To: All Distributors – North America  
Attn: General Service Manager  
Subject: **Safety Recall 04C-2**  
Series 50 Exhaust Temperature Sensor

Subject: **Safety Recall 04C-2**  
**Series 50 Exhaust Temperature Sensor**

### 18SP465—Install Exhaust Gas Temperature Measurement Kit 23524969 on a Series 50 Engine

**Figure 1 - Adapter insertion location**

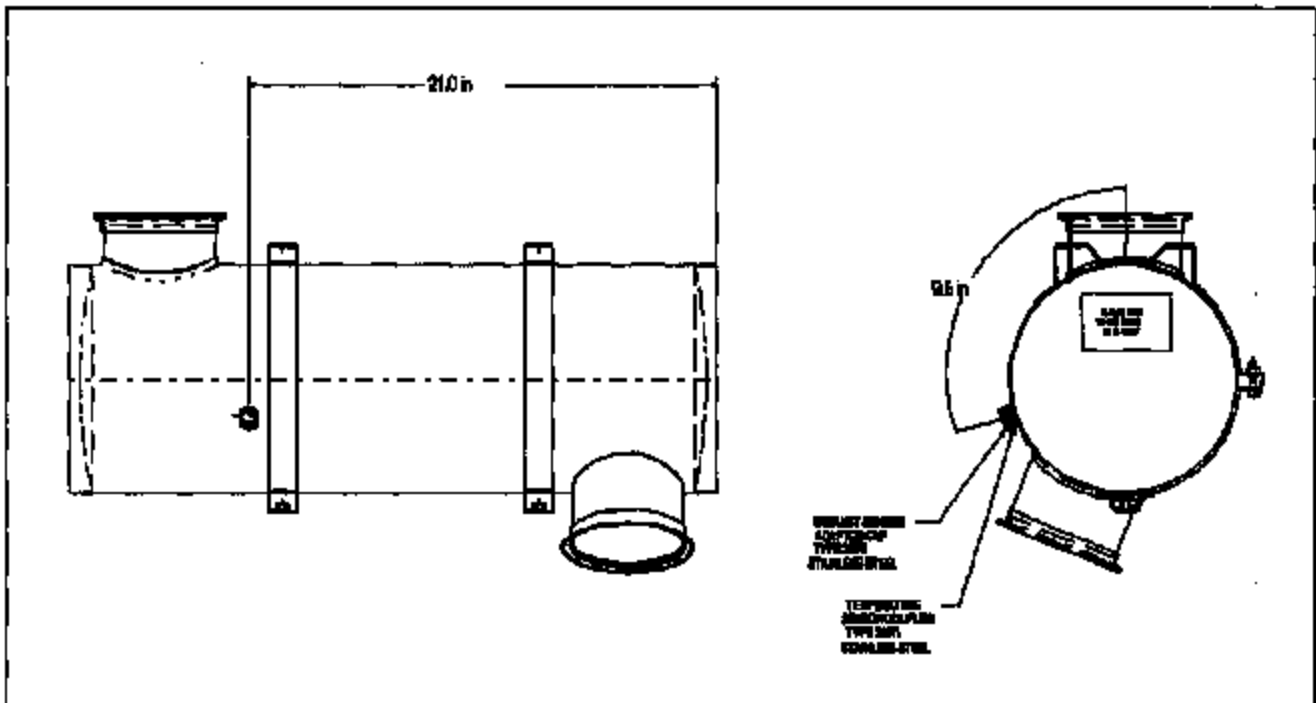
2. With the engine at ambient temperature, mark the adaptor insertion location on the heat shield. See Figure 1. The dimensions shown indicate the exact adaptor location.

**NOTE:** To ensure accuracy, all measurements must be made on the muffler/catalyst assembly and not on the heat shield.

3. Using the adaptor insertion mark as the centerline of the hole, carefully drill a two-inch diameter hole through the muffler/catalyst heat shield with a hole saw or comparable tool. Remove any sharp edges and/or burrs from the outside surface of the heat shield.
4. Repeat the measurements described in step 2 and mark the location of the adaptor on the muffler/catalyst outer shell. Using a 16.5 or 17mm O.D. drill bit, drill through the muffler/catalyst assembly. Remove any sharp edges and/or burrs from this surface.

5. With the power harness disconnected from the engine ECM, seat the exhaust temperature sensor adaptor (Item 3) on the surface of the muffler/catalyst assembly. The threads of the adaptor should face toward the rear of the bus. Install the adaptor cap (Item 4) by rotating it approximately four full turns and weld the adaptor in place.

**Figure 2 - Proper Routing of Temperature Sensor Harness**

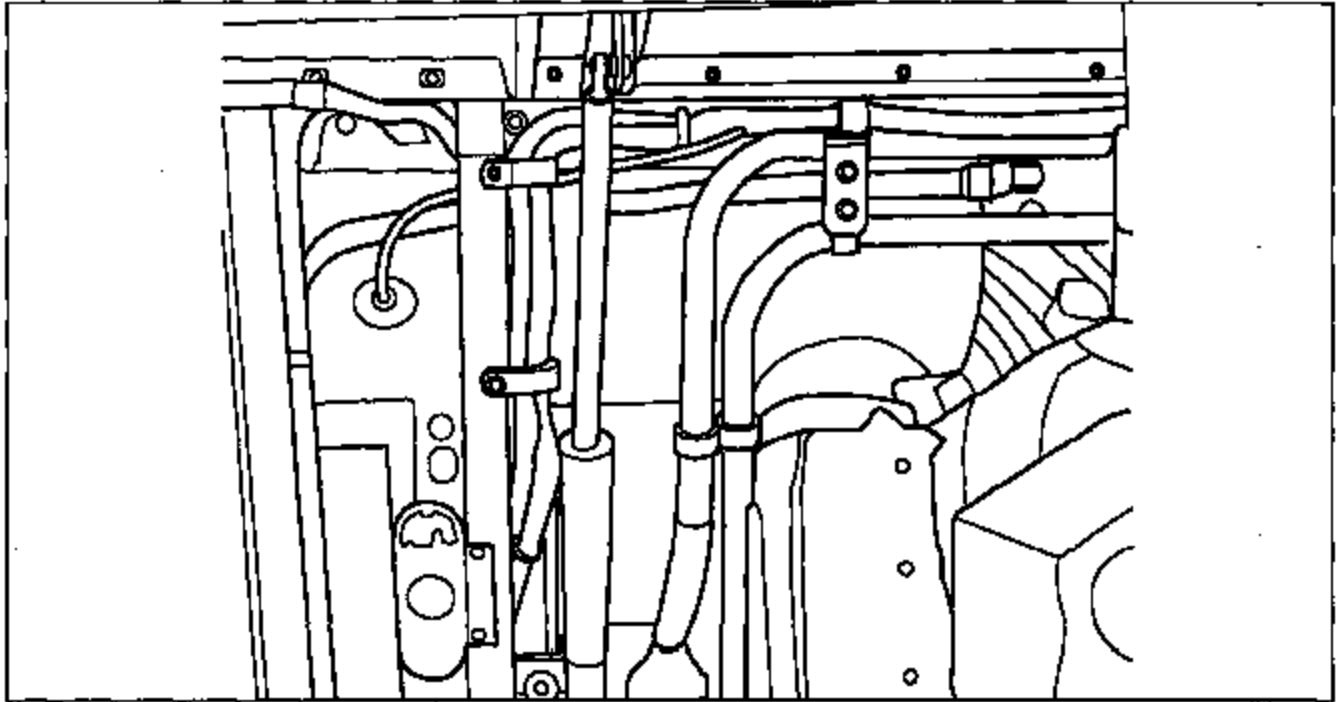
6. While the adaptor is cooling, remove the adaptor cap (Item 4). With the adaptor at ambient temperature, install the exhaust temperature sensor (Item 1). See Figure 2 and note arrows for correct sensor cable routing. Use care to route the cable away from the heat shield surface.

9. Connect the two-pin female Weather Pack® connector on the electrical harness to the male connector on the end of the exhaust temperature sensor. Route the sensor cable and conduit along existing wiring conduit in the engine compartment and tie-wrap to secure them in place.
